Applicant: Dan Walsh; Raspberry Ridge Limited Partnership
Consultant: Nathan Bruno; LHB, Inc.
Project: Raspberry Ridge II Multi-family Housing Addition
Location: 9 7th Avenue South: Hopkins
Rule(s): 4 and 5
Reviewer(s): LLH/BCO

DRAWING TITLE:
GRADING PLAN

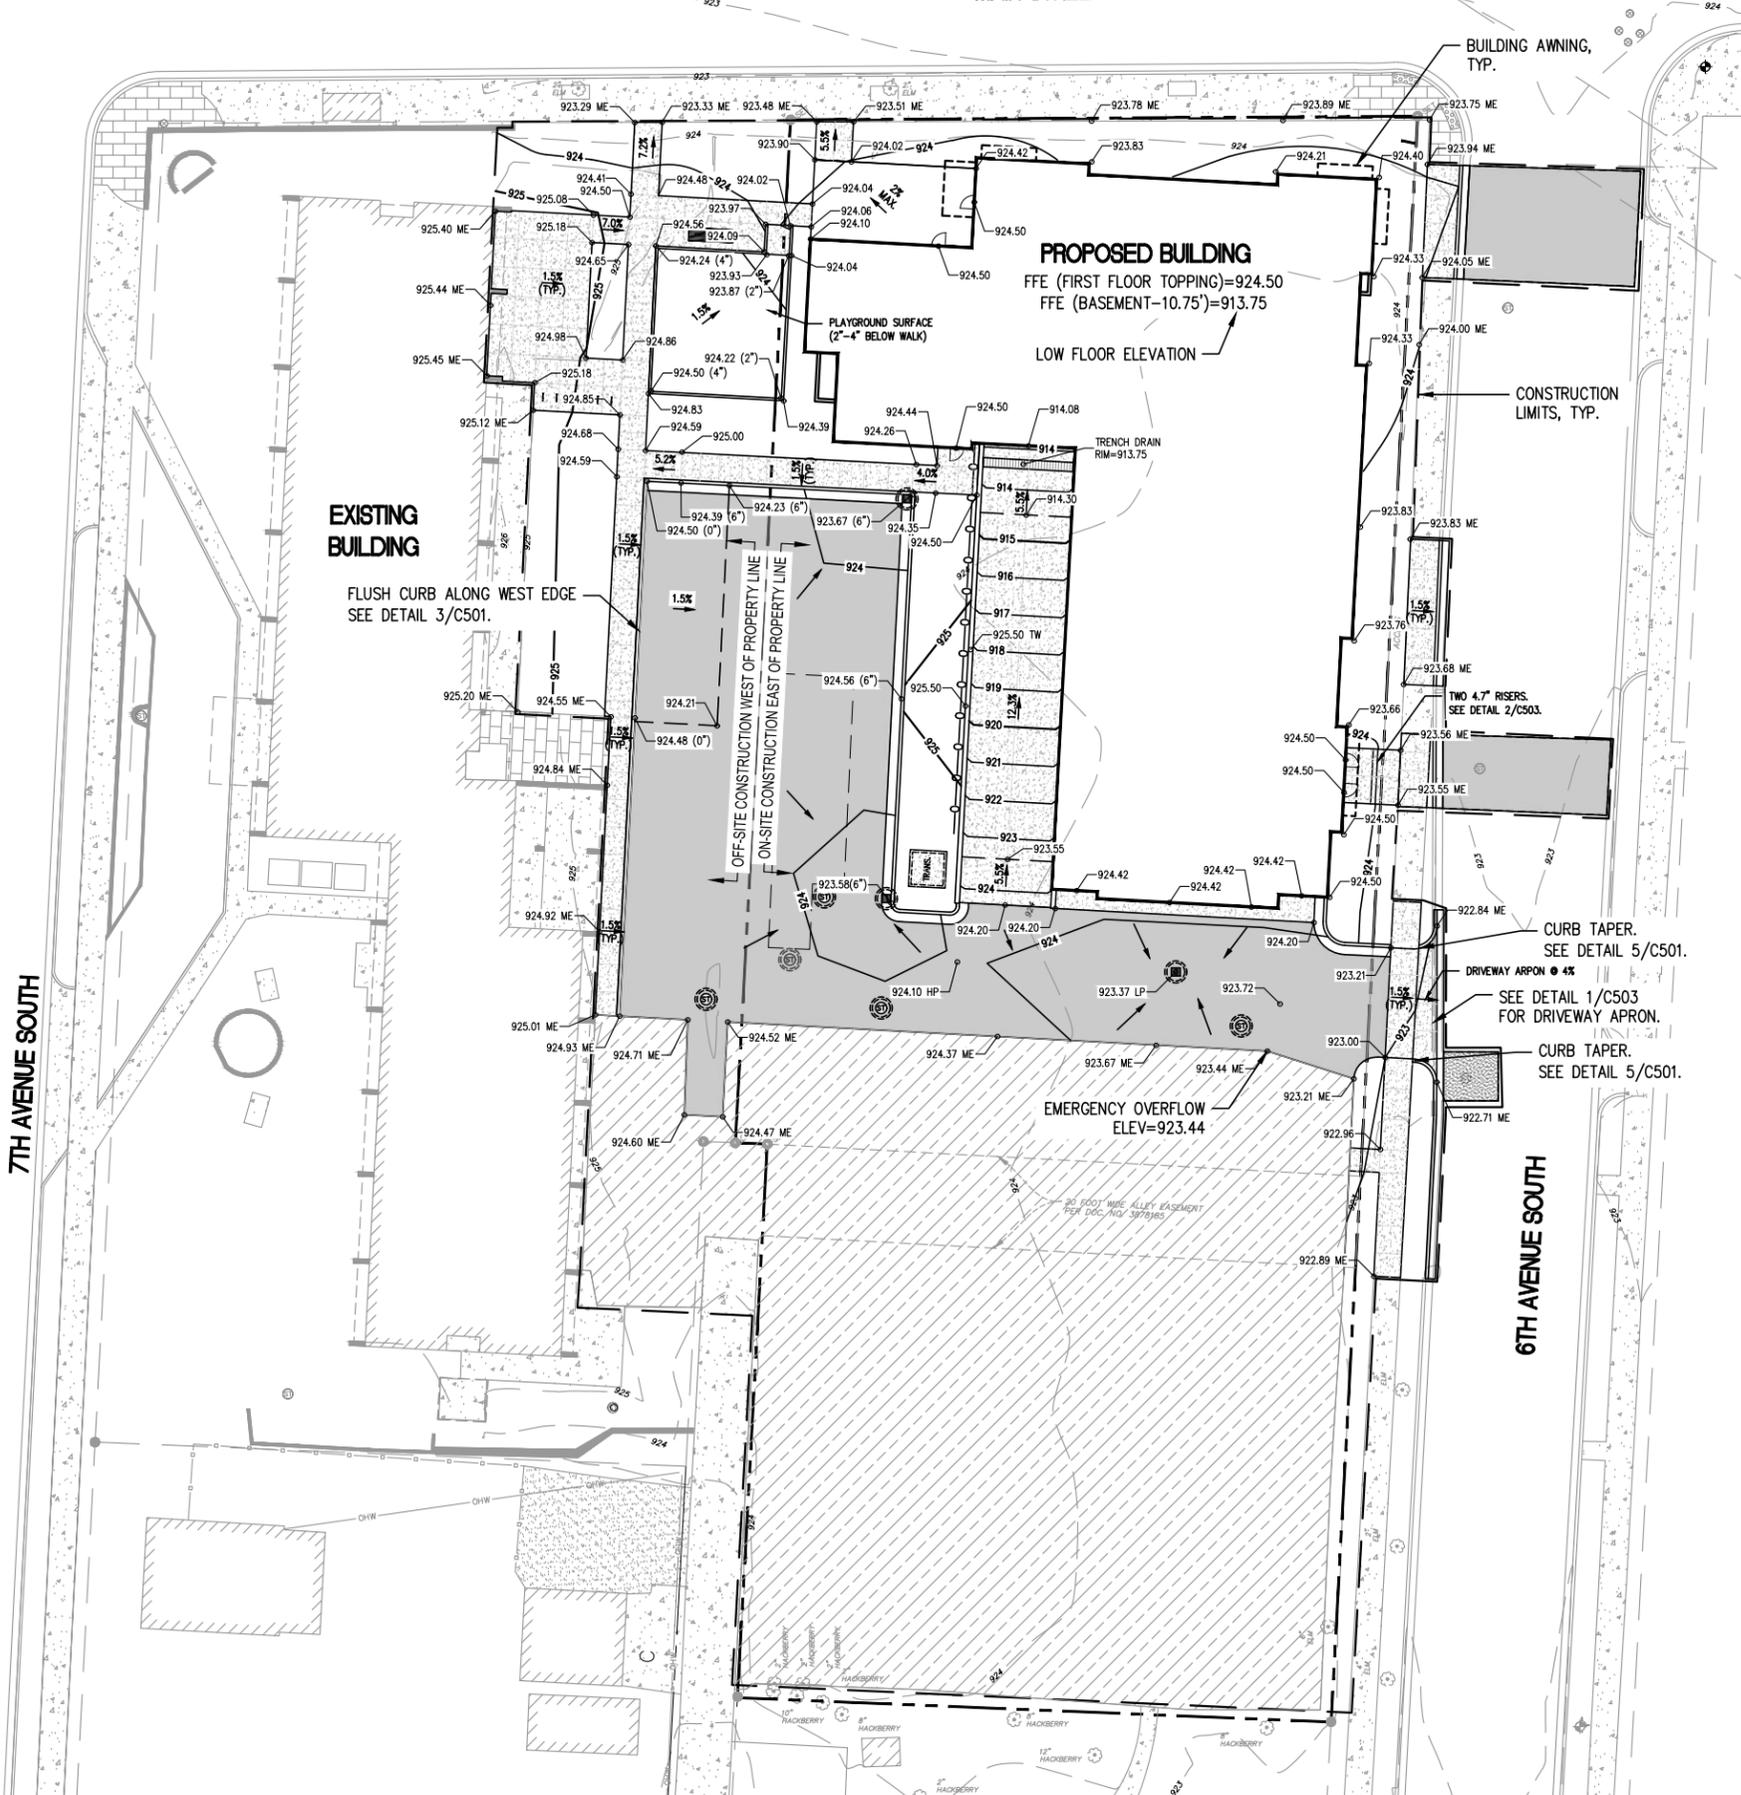
5. The site plans must be amended to identify the low floor and low opening elevation of the existing structure on-site.
